Re: Consumer Electronics Group/  
Electronic Industries Association filing  
in MM Docket 87-268

Advanced Television Systems  
and Their Impact on the  
Existing Television Broadcast  
Service

COMMENTS OF THE CONSUMER ELECTRONICS GROUP  
of the  
ELECTRONIC INDUSTRIES ASSOCIATION

Figure 2: "Just Perceptible" Interference, UHF TV IF Beat

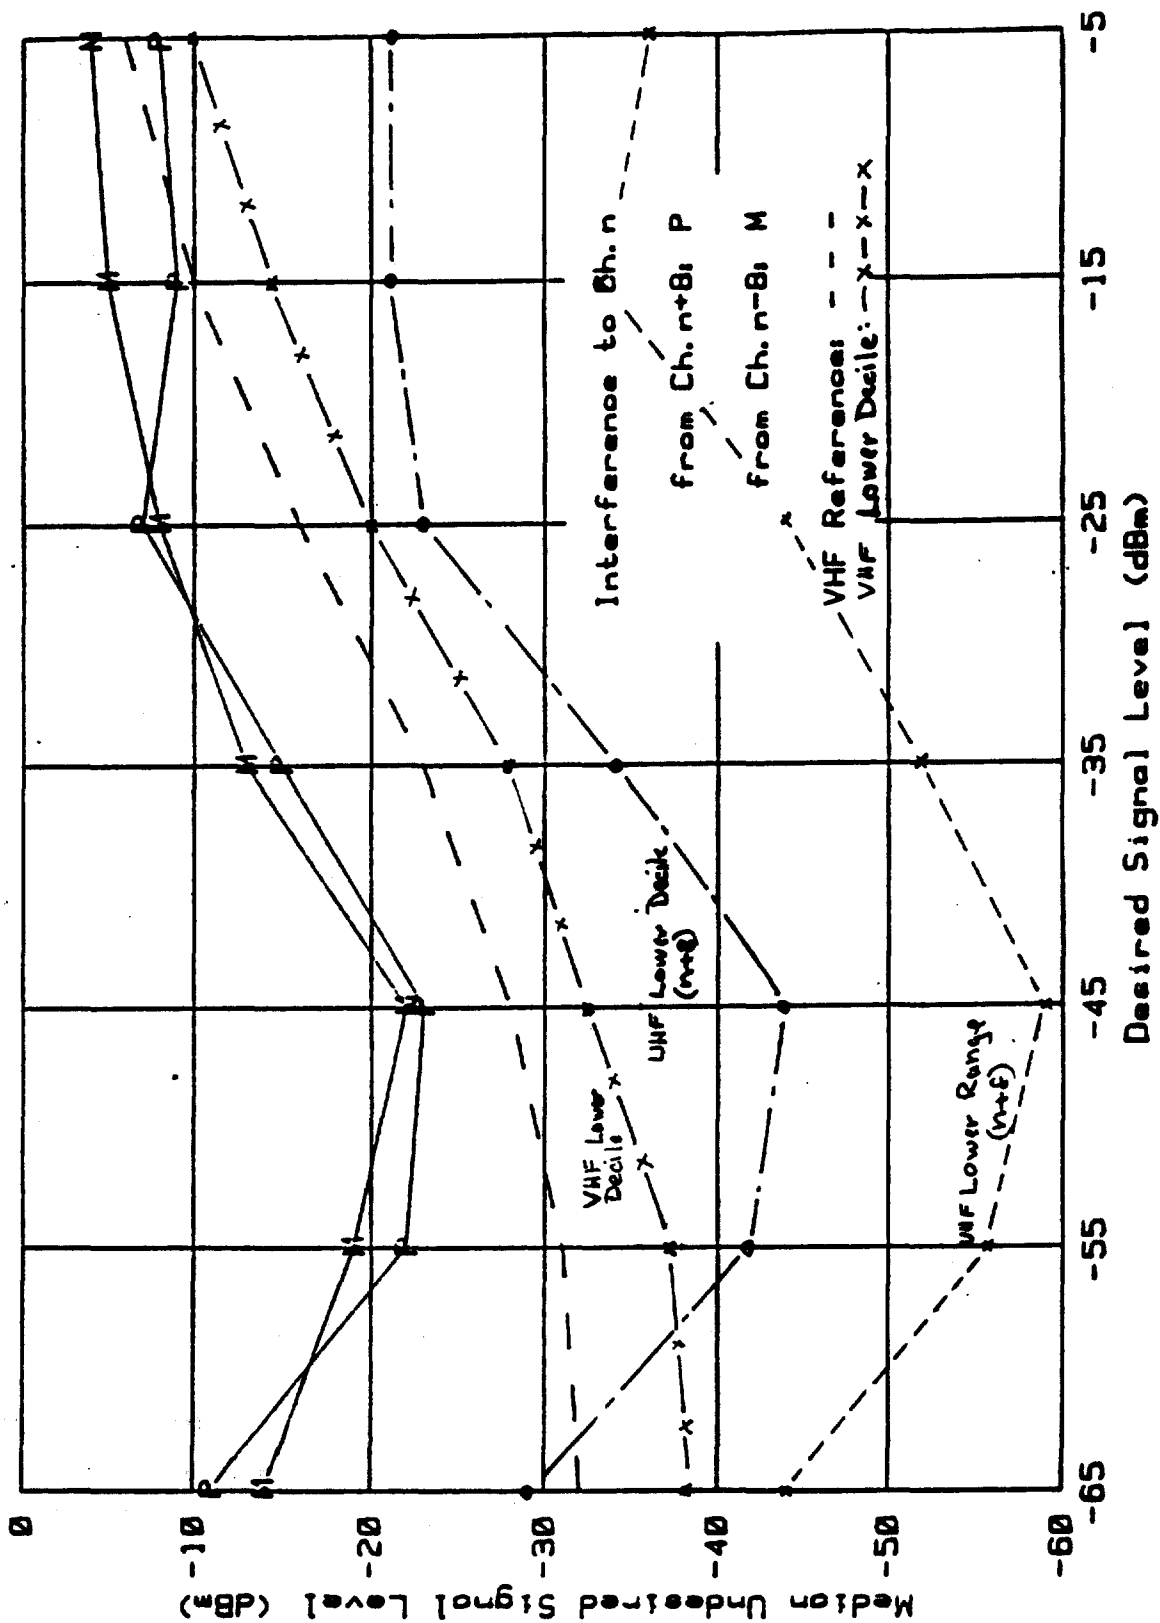
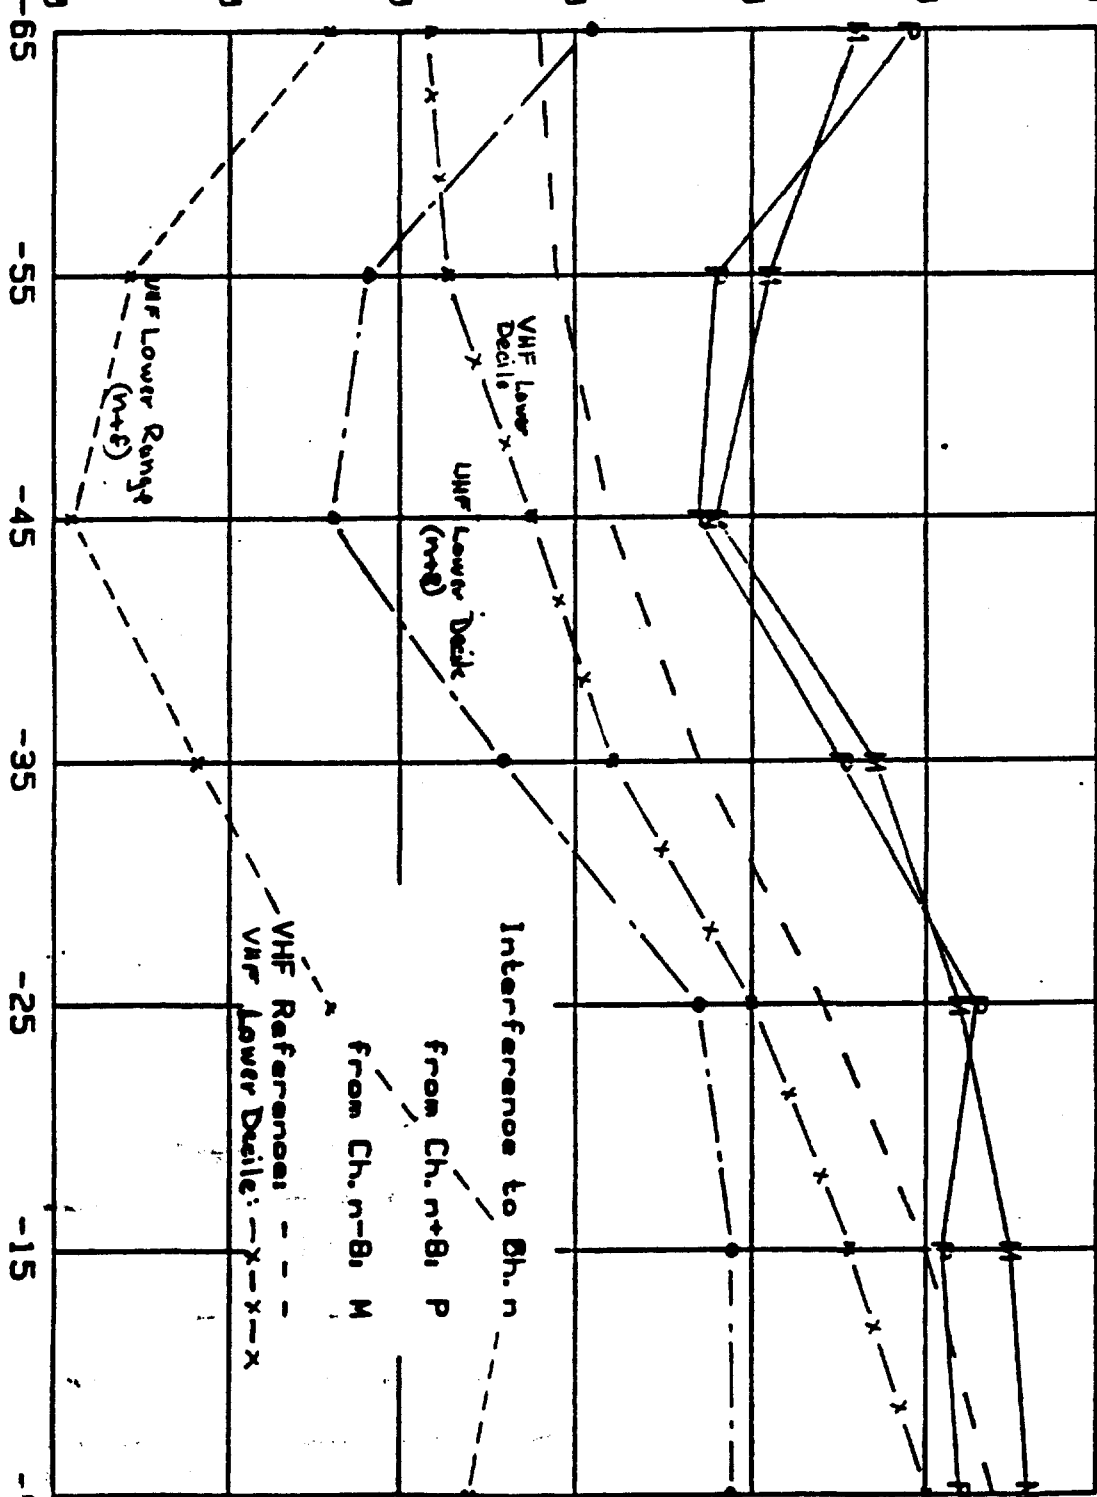
Figure 2 from the memorandum is attached with the VHF and UHF lower decile and UHF lower range performance added. It illustrates that a change in this taboo is not justified. The UHF lower decile performance is not as good as the VHF lower decile performance.
